MANUFACTURERS' RECEIVER TROUBLE CURES

VOLUME 3

A RIDER Publication

Fig. 47 — Philco

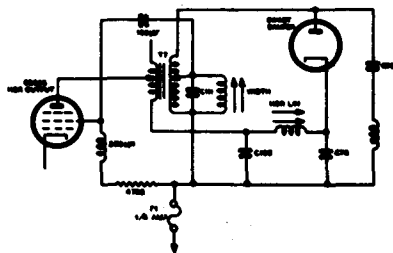
Reducing a-c current through fuse (see Fig. 47).

To reduce the a-c current through the h-v fuse, this fuse (*F1*) is rewired as shown in the figure. In addition, the value is changed from $\frac{3}{8}$ ampere to $\frac{1}{4}$ ampere (part No. 45-2656-8). Increased production is also afforded by this change, already made in production run 4.

Fig. 48 — Philco

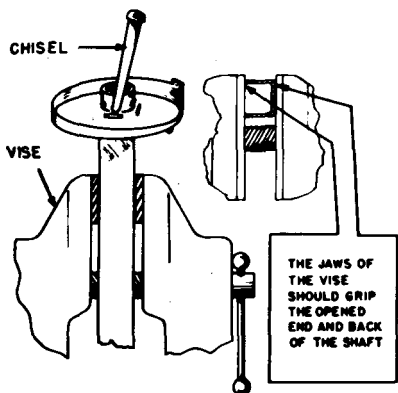
PHILCO Model 51-PT1200
Replacement of fine-tuning cam (see Fig. 48).

The tuner shaft arrangement in the above model is different in that the channel selector knob is secured to the channel-selector shaft by means of an Allen screw. Often a serviceman may inadvertently pull on the knob without removing the set screw. This will sometimes result in a cracked bakelite fine-tuning cam. The shaft and bakelite cam assembly, part No. 76-5846, is no longer available as a replacement item.

Fig. 49 — Philco

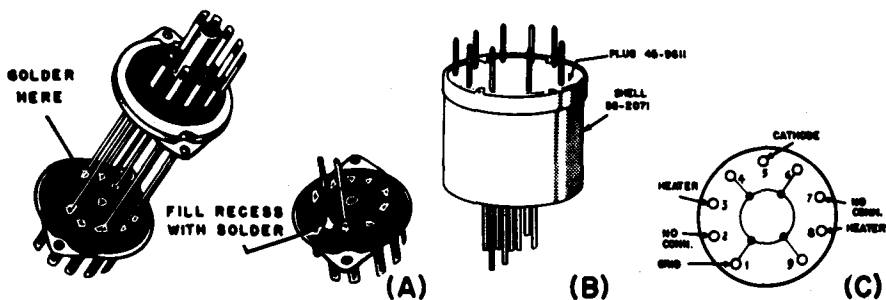
1. Strip the No. 18 wire of all insulation and cut nine lengths of this wire to approximately $1\frac{1}{4}$ inch.
2. Insert the nine lengths of cut wire into the holes of both sockets. This is done to hold the nine wires in the proper position for soldering.
3. Solder the nine lengths to the bottom socket with non-corrode solder. Make sure the solder runs down the pins and makes good electrical bond with the socket pins and also fills the recesses of the socket so that the pins are rigid.
4. When all nine pins have been soldered to the bottom socket, remove the top socket and trim the nine pins to approximately $\frac{1}{4}$ inch above the face of the socket.

Fig. 50 — Philco

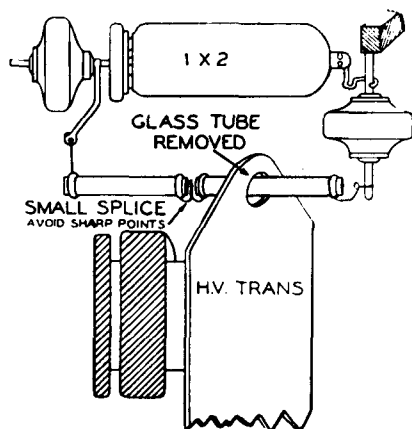
All field replacements of 2-meg resistors should be made with the newer special carbon mix type. In all of the above series receivers two of these resistors are to be used in series as the d-c return path for the

Fig. 51 — Philco

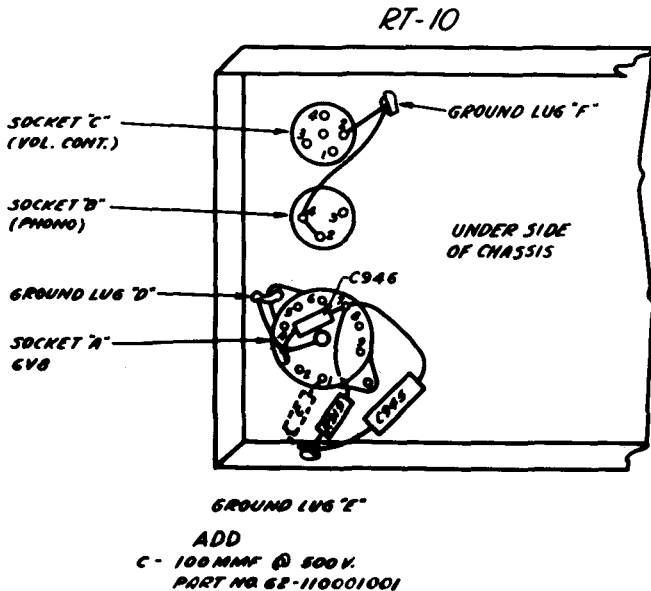
1. Study the pictorial diagram carefully.
2. Remove bare wire connecting pin 2 of socket B and ground lug D.
3. Remove ground end of C946 from pin 2 of socket B and connect to pin 3 of socket A as shown.

Fig. 52 — Philco

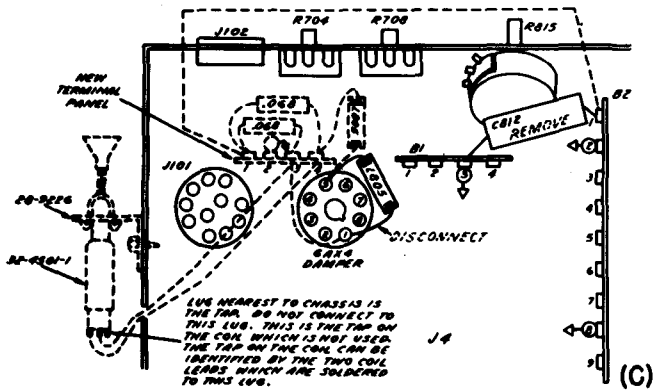
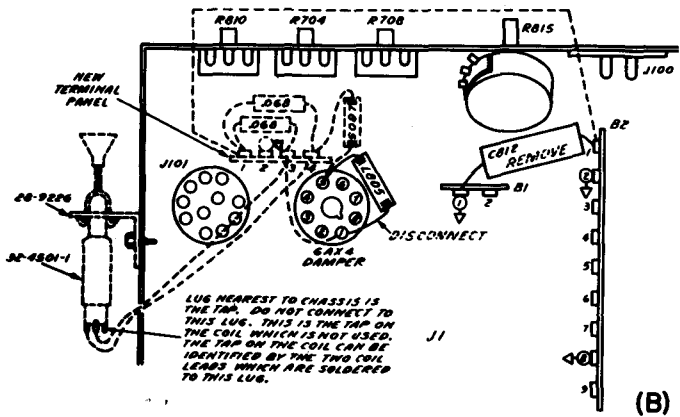
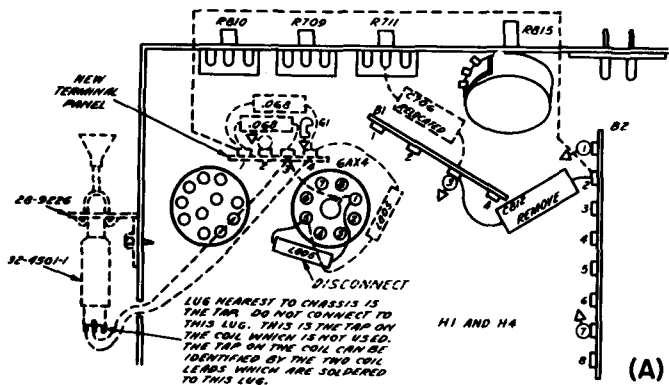
6. Disconnect the r-f choke *L805* from the damper-tube socket pin 1

Fig. 53 — Philco

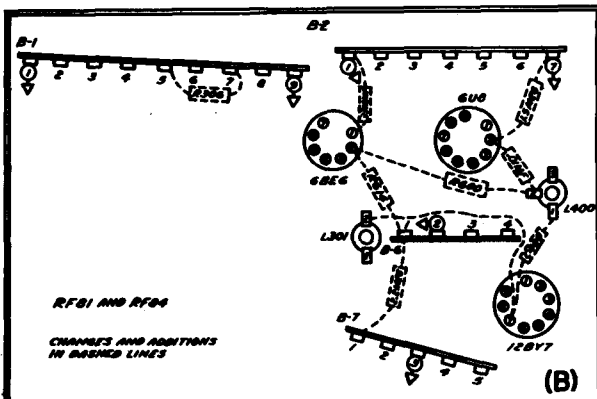
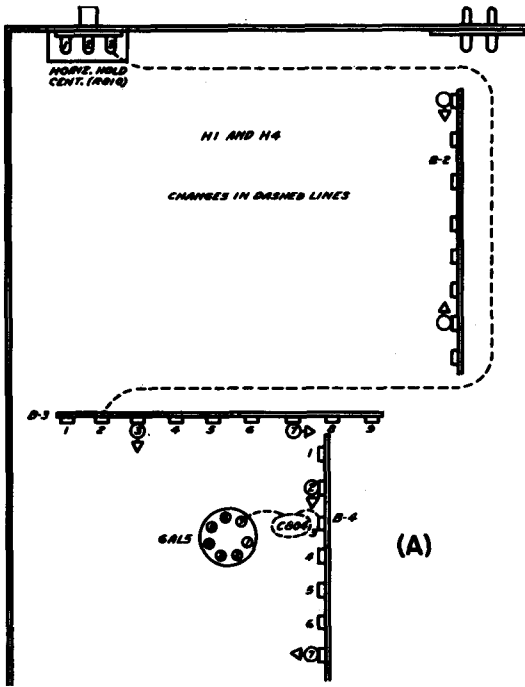
2. Remove lead between lug 2 of terminal panel *B3* and lug 3 of horizontal-centering hold control (*R810*). Refer to part (A) of the figure.

Fig. 55 — Philco

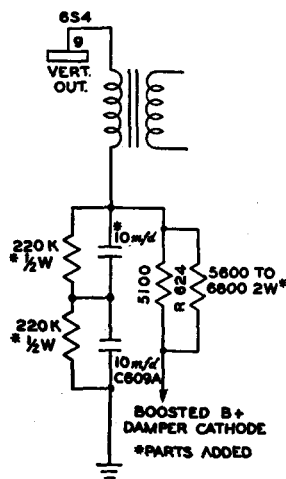
If vertical foldover is encountered at the bottom of the screen, in most cases it is due to the 6S4 be-

Fig. 59 — Philco

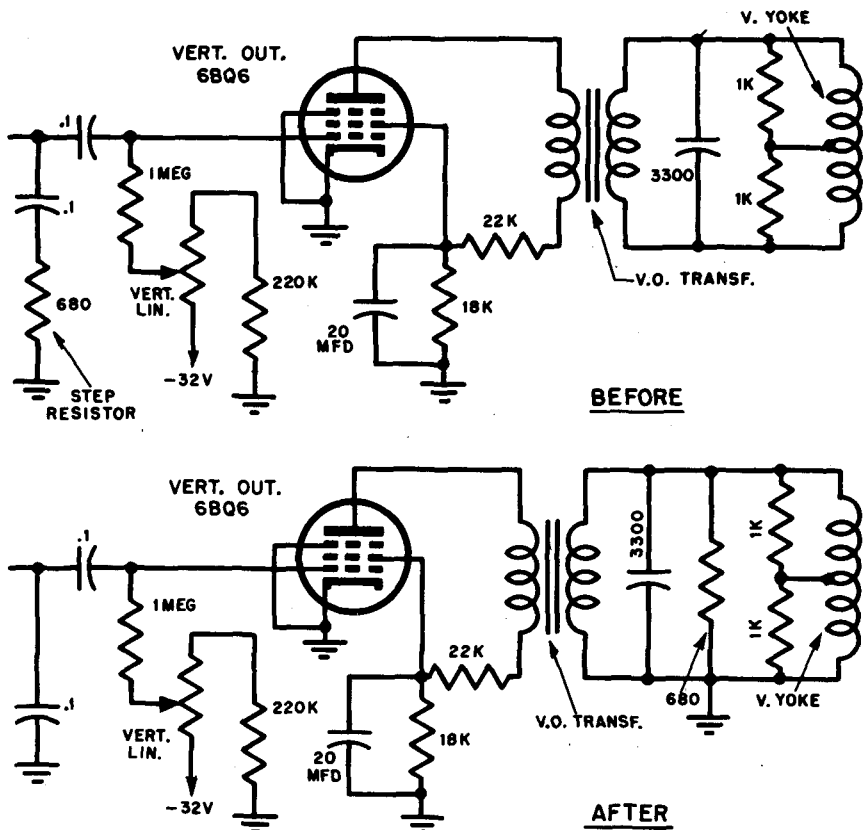
Some cases of vertical-output transformer hum have been reported. In order to minimize the buzz in the transformer (part No. 32-8515), the peak voltage on the transformer primary and secondary can be reduced by the following expedient without any compromise in performance. This reduction in peak voltage is accomplished by removing the 680-ohm step resistor in the vertical-

Fig. 60 — Philco

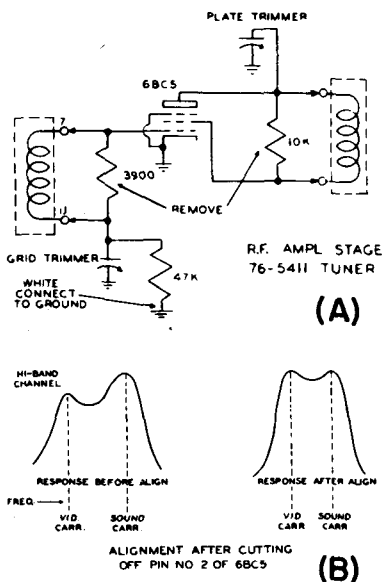
Recently it was found that by introducing a slight amount of regeneration in the r-f amplifier stage, additional gain of another 20 percent may be realized on the high-band channels and especially near the upper end of the high band. This regeneration can be very easily introduced by simply clipping off pin 2 of the r-f amplifier tube. Doing this introduces an impedance common to the suppressor and cathode. This common impedance is the internal cathode tie and the cathode lead. The relatively high capacitance between the plate and suppressor provides a feed-back path which causes some amount of regeneration in the r-f amplifier tube. The circuit actually takes the form of a modified Colpitts oscillator. After pin 2 is clipped off and the tube is reinserted, the tuner should be realigned to complete the modification of the r-f stage for good fringe performance. It is necessary to realign the r-f stage because introducing regeneration tends to produce a definite peak on the sound side (high-frequency side) of the response curve, therefore the r-f stage must be realigned so that the sound and video peaks are equal. It will be found that it is necessary to retune the grid and plate trimmers to give correct response. See part (B) of the figure.

As was stated before, introducing this type of regeneration only makes a difference on the high-band channels. On the low channels no apparent difference is noted. It will also be noticed that regeneration tends to make alignment more critical so, in general, improved gain is realized only on the channel used for alignment and the adjacent channels.

Fig. 63 — Philco

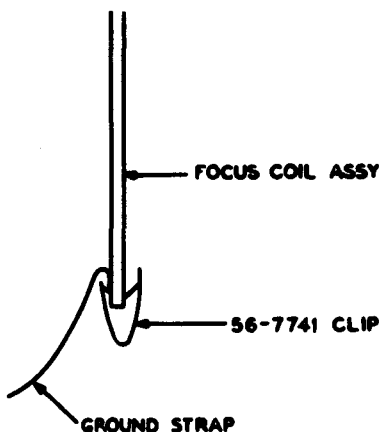
PHILCO 1950 models
with built-in antenna
Reducing harmonic beat
(see Fig. 63).

Fig. 64 — Philco

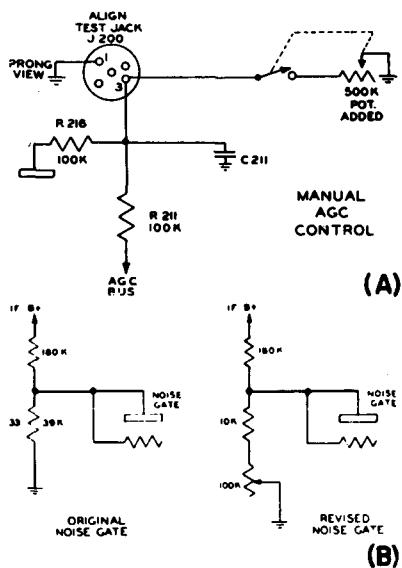
The variable control has an advantage over the regular Fringe-Normal kit 45-1732 in locations where signal level and noise conditions vary over relatively short periods of time.

Under conditions of heavy noise, as would be experienced in some fringe areas, it is advantageous to be able to manually control the bias on the noise-gate diode, thus controlling the clipping level of the tube. A circuit to accomplish this is shown in part (B) of the figure. The 39,000-ohm resistor is replaced by a 10,000-ohm resistor in series with a 100,000-ohm potentiometer.

Fig. 65 — Philco

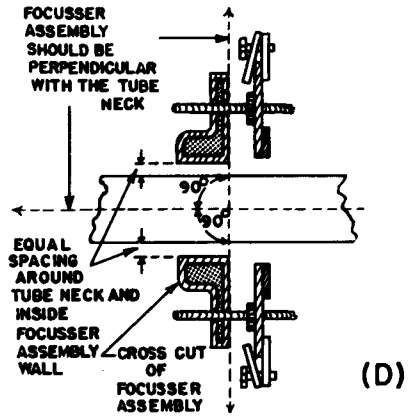
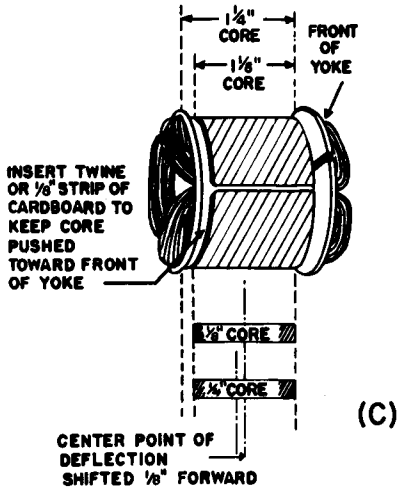
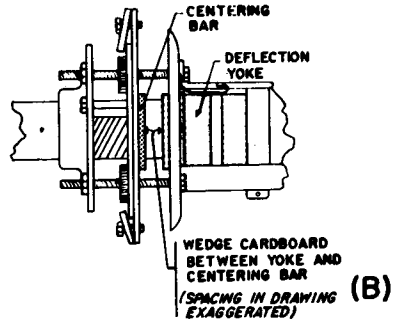
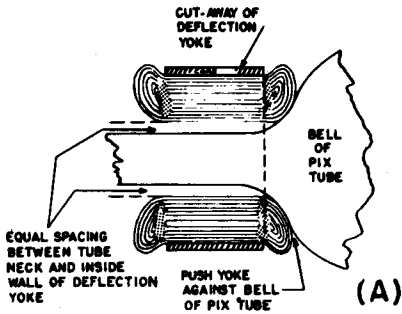
2. Examine the deflection yoke to make sure it is concentric with the neck of the tube and pushed as close to the bell of the picture tube as
